## Report to Council: Policy Amendments – Southeast Industrial Area Structure Plan (Ward 12), M-2018-001

ISC: UNRESTRICTED  
CPC2018-0863  
Page 1 of 8

This report proposes Administration-initiated amendments to the *Southeast Industrial Area Structure Plan (ASP)* to:

- remove the 400 metre setback from the decommissioned Phosphogypsum Stack Two; and
- add a 450 metre setback to the disposal area of operating hazardous waste management facilities.

### Schedule A

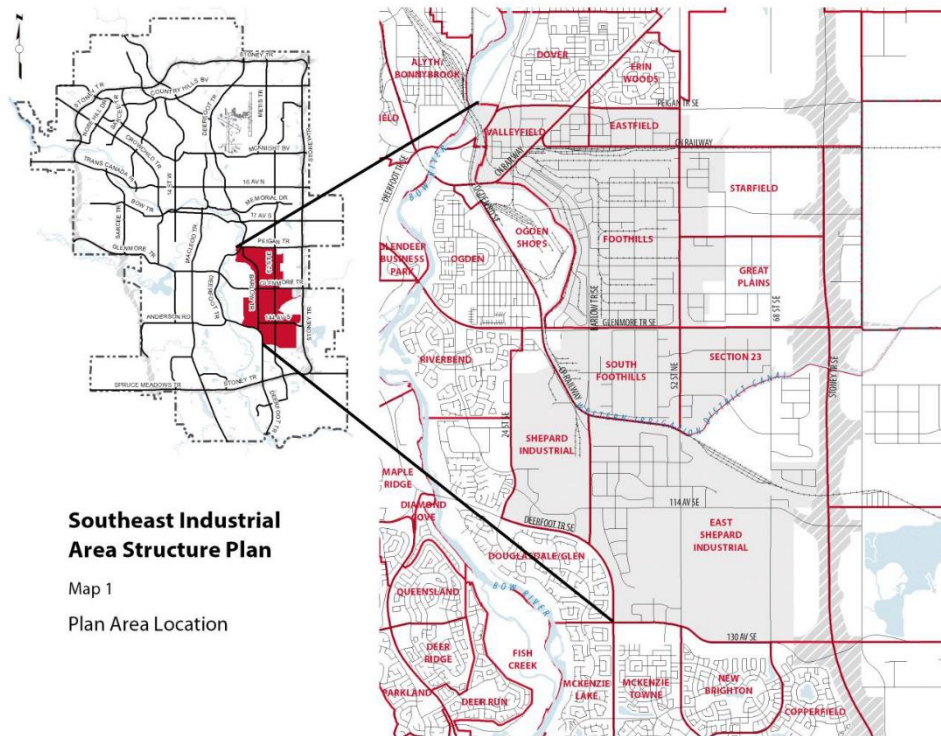
- (b) Delete the existing Map 1 entitled "Plan Area Location" and replace with revised Map 1 entitled "Plan Area Location", as attached as Schedule A.

### Schedule B

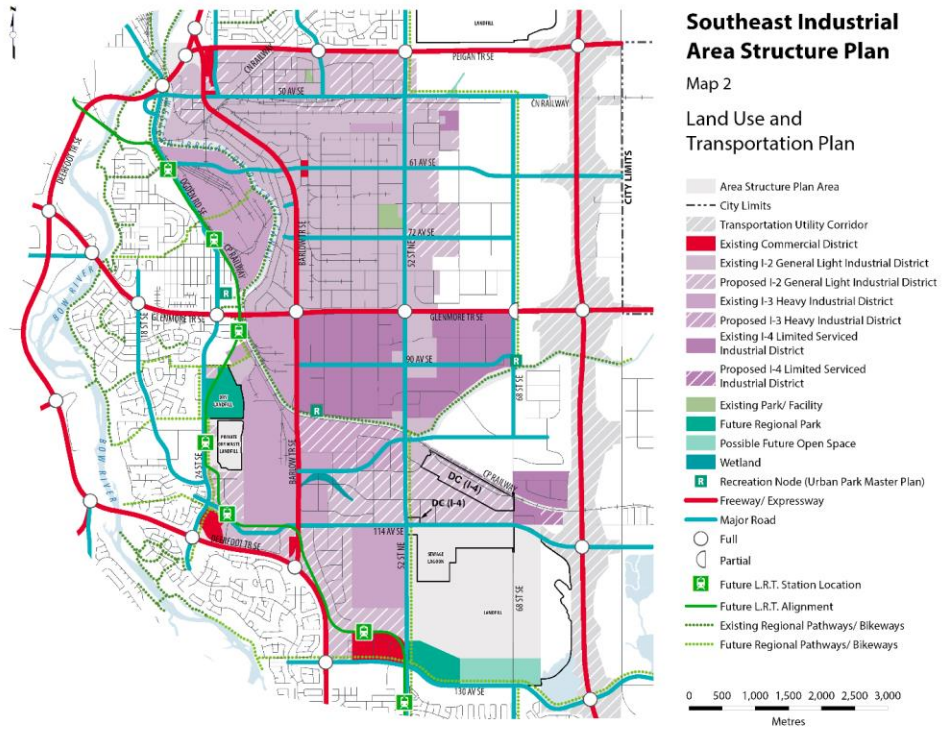
- (c) Delete the existing Map 2 entitled "Land Use and Transportation Plan" and replace with revised Map 2 entitled "Land Use and Transportation Plan", as attached as Schedule B.

**Schedule C**

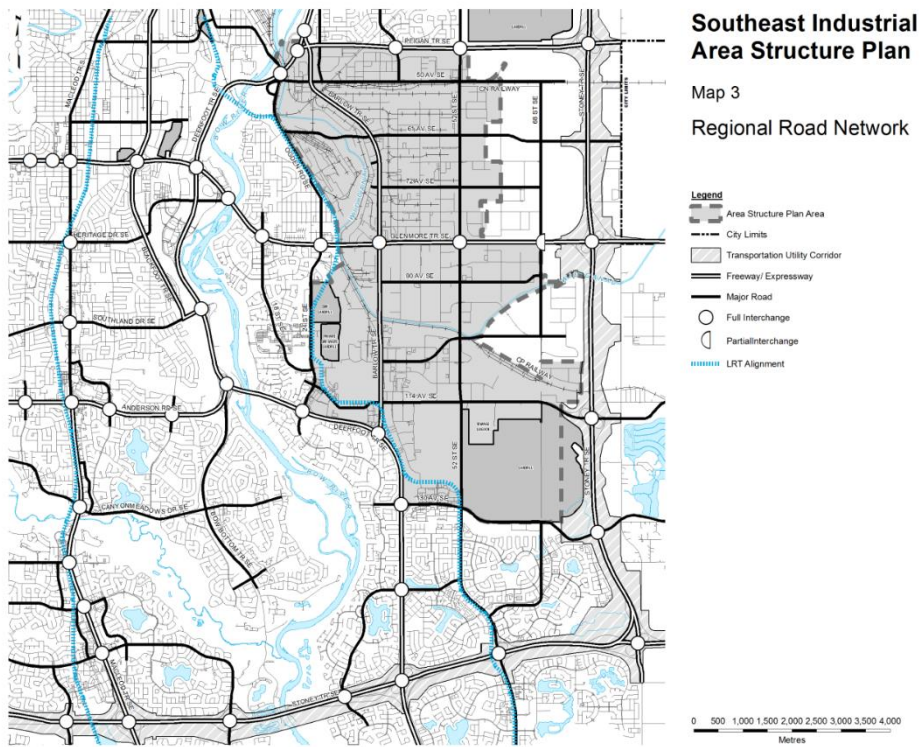
- (e) Delete the existing Map 3 entitled "Regional Road Network" and replace with revised Map 3 entitled "Regional Road Network", as attached as Schedule C.

### Schedule D

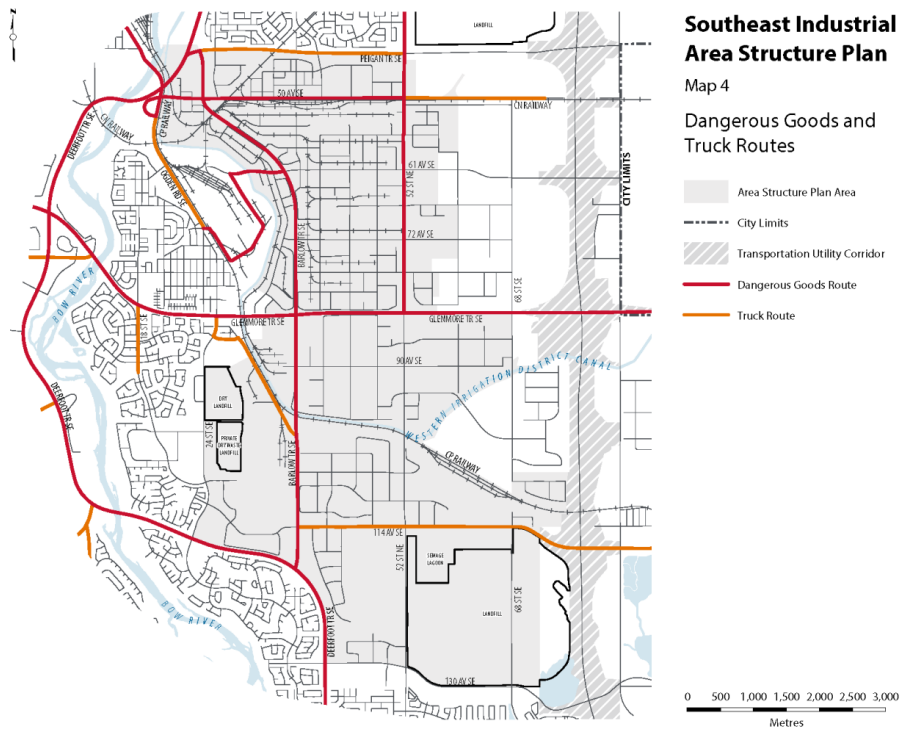
- (f) Delete the Map 4 entitled "Dangerous Goods and Truck Routes" and replace with revised Map 4 entitled "Dangerous Goods and Truck Routes", as attached as Schedule D.

### Schedule E

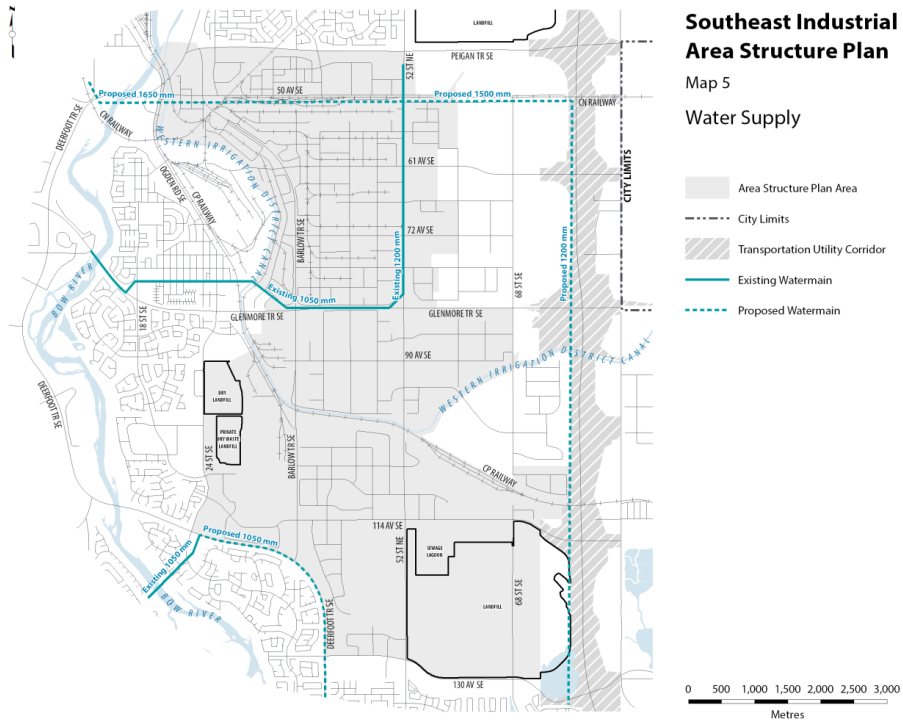
- (g) Delete the existing Map 5 entitled "Water Supply" and replace with revised Map 5 entitled "Water Supply", as attached as Schedule E.
  - (h) Delete the existing Map 6 entitled "Sanitary Sewer System" and replace with revised Map 6 entitled "Sanitary Sewer System", as attached as Schedule F.

### Schedule G

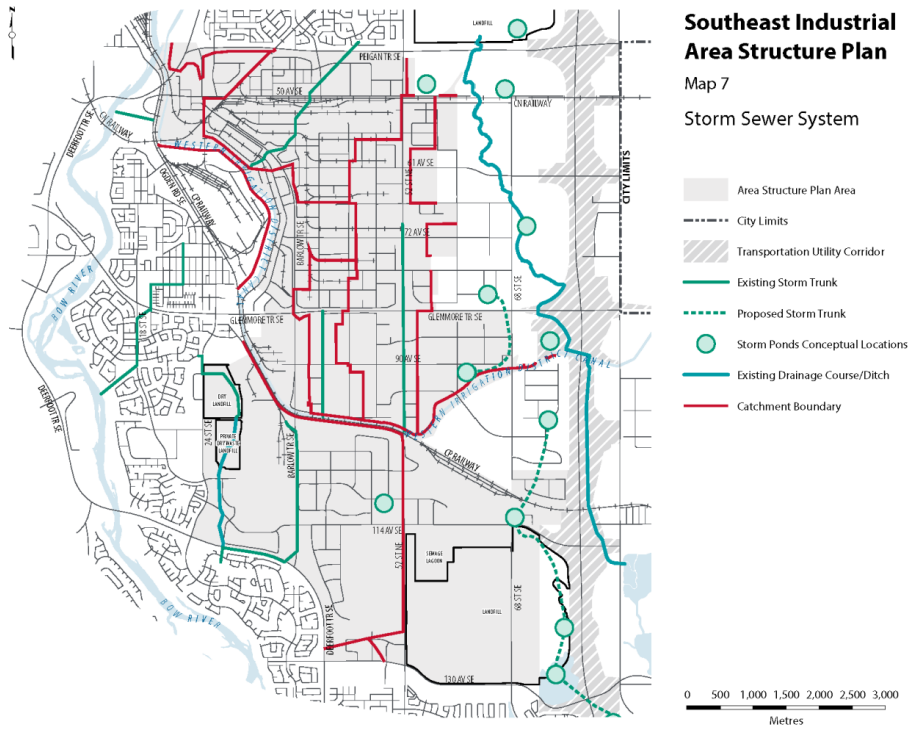
- (i) Delete the existing Map 7 entitled "Storm Sewer System" and replace with revised Map 7 entitled "Storm Sewer System", as attached as Schedule G.

**Schedule H**

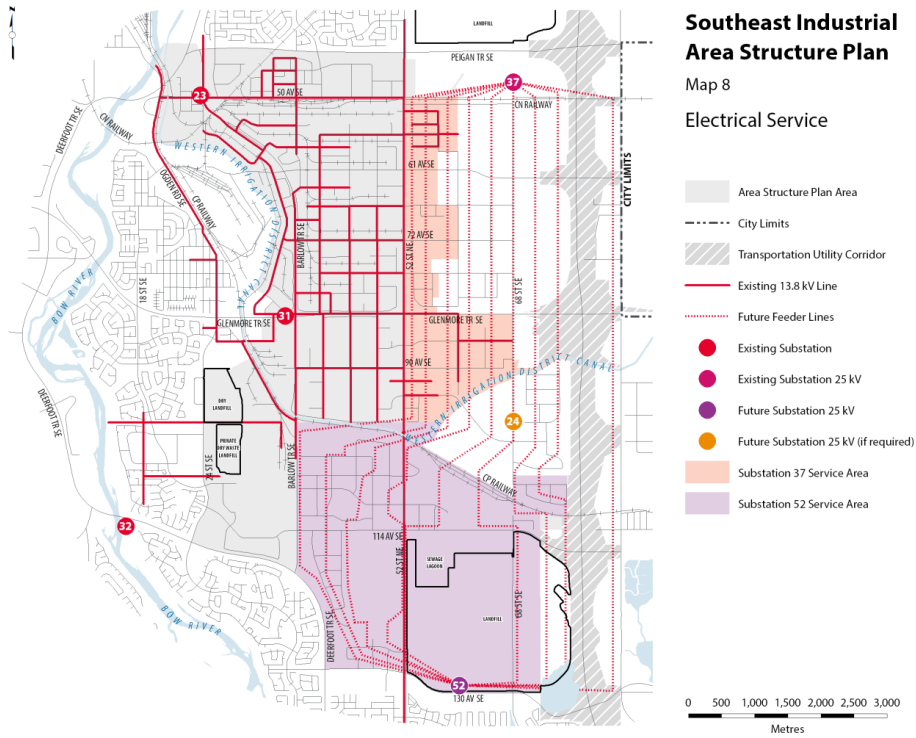
- (j) Delete the existing Map 8 entitled "Electrical Service" and replace with revised Map 8 entitled "Electrical Service", as attached as Schedule H.

### Schedule I

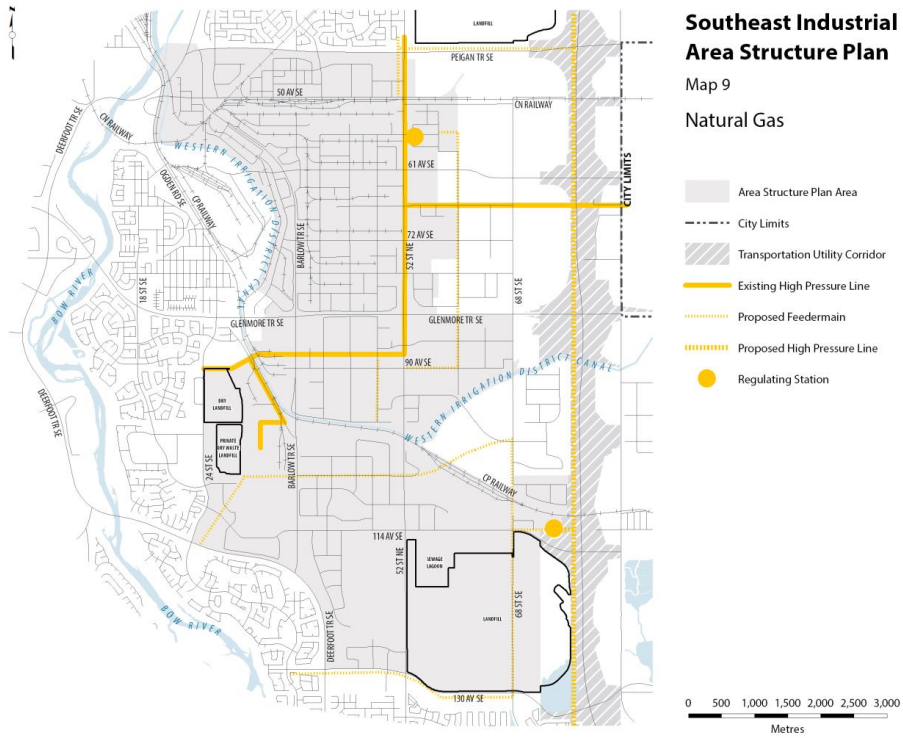
- (k) Delete the existing Map 9 entitled "Natural Gas" and replace with revised Map 9 entitled "Natural Gas", as attached as Schedule I.
  - (l) Delete the existing Map 10 entitled "Telephone and Cable Services" and replace with revised Map 10 entitled "Telephone and Cable Services", as attached as Schedule J.

### Schedule A

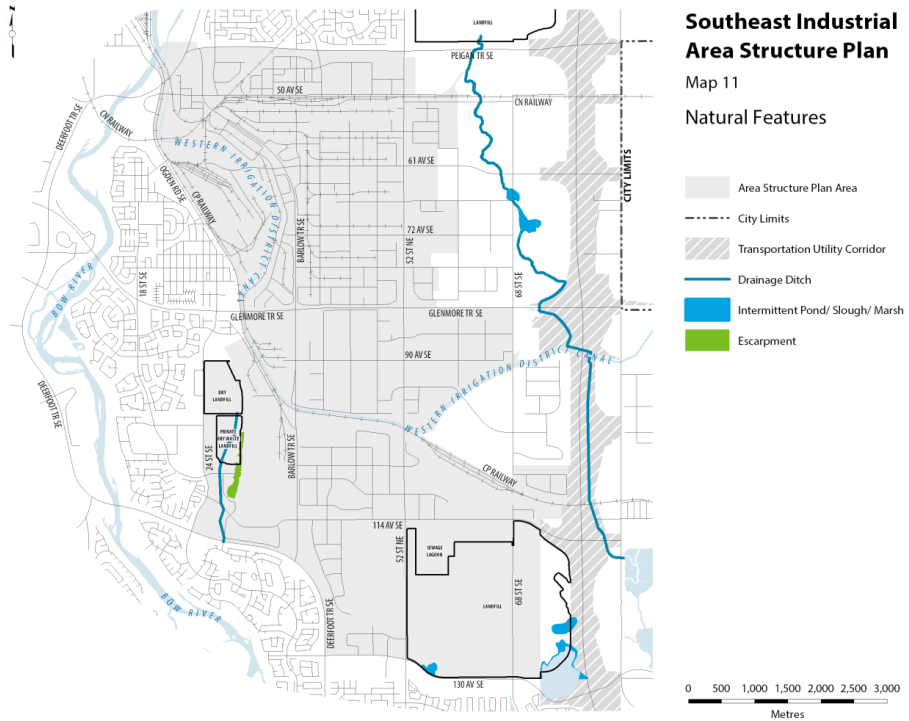
- (a) In the Table of Contents and subsection 7.4.3 delete "Phosphogypsum Pond" and replace with "Hazardous Waste Management Facilities";
  - (b) Delete the existing Map 11 entitled "Natural Features" and replace with revised Map 11 "Natural Features", as attached as Schedule A;

**Schedule B**

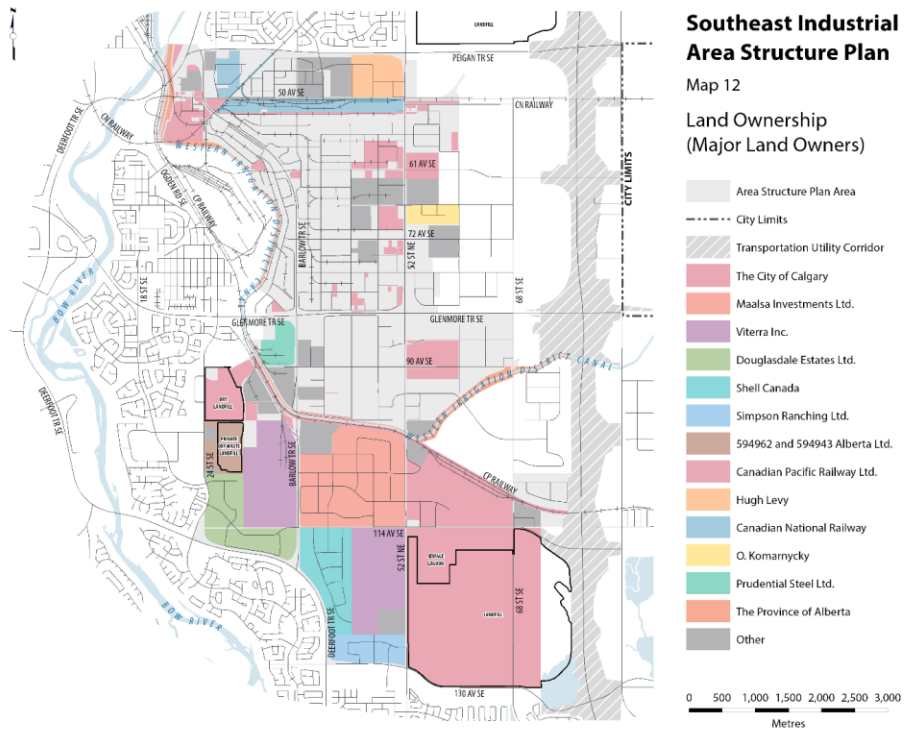
- (c) Delete the existing Map 12 entitled "Land Ownership (Major Land Owners)" and replace with revised Map 12 entitled "Land Ownership (Major Land Owners)", as attached as Schedule B;

### Schedule C

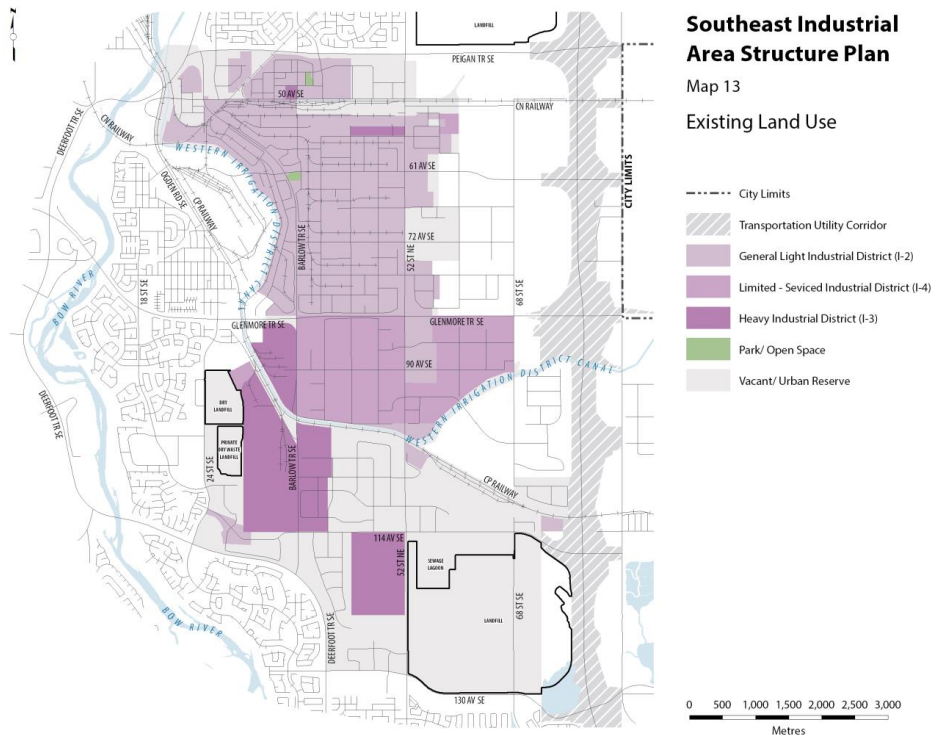
- (e) Delete the existing Map 13 entitled "Existing Land Use" and replace with revised Map 13 entitled "Existing Land Use", as attached as Schedule C;

### Schedule D

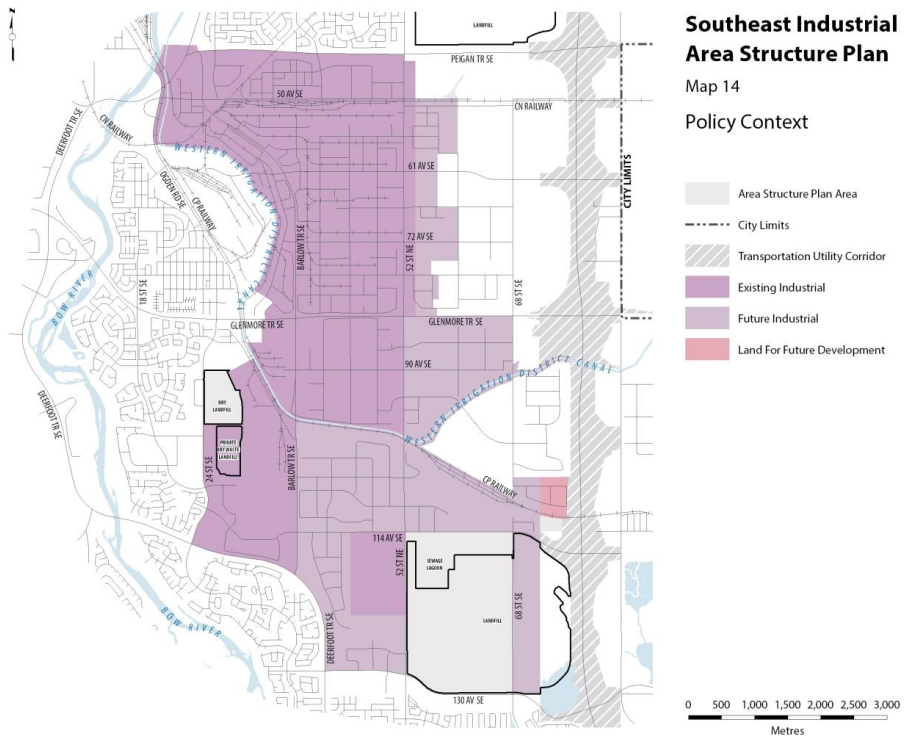
- (f) Delete the existing Map 14 entitled "Policy Context" and replace with revised Map 14 entitled "Policy Context", as attached as Schedule D;
  - (g) Delete the existing Map 15 entitled "Tri-Party Agreement" and replace with revised Map 15 entitled "Tri-Party Agreement", as attached as Schedule E;

### Schedule F

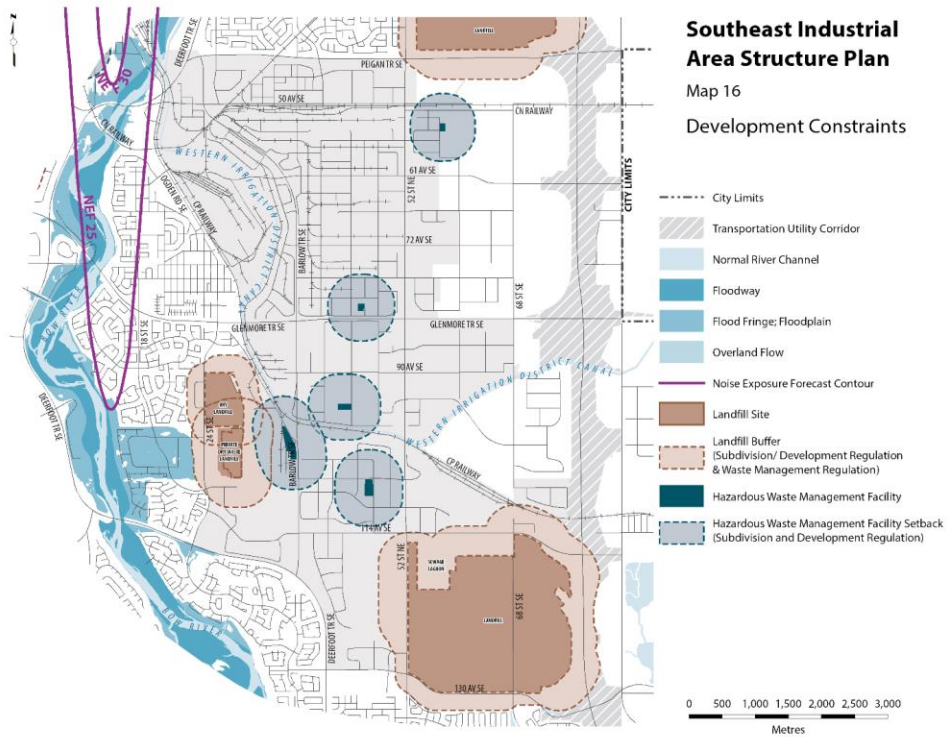
- (i) Delete the existing Map 16 entitled "Development Constraints" and replace with revised Map 16 entitled "Development Constraints", as attached as Schedule F;
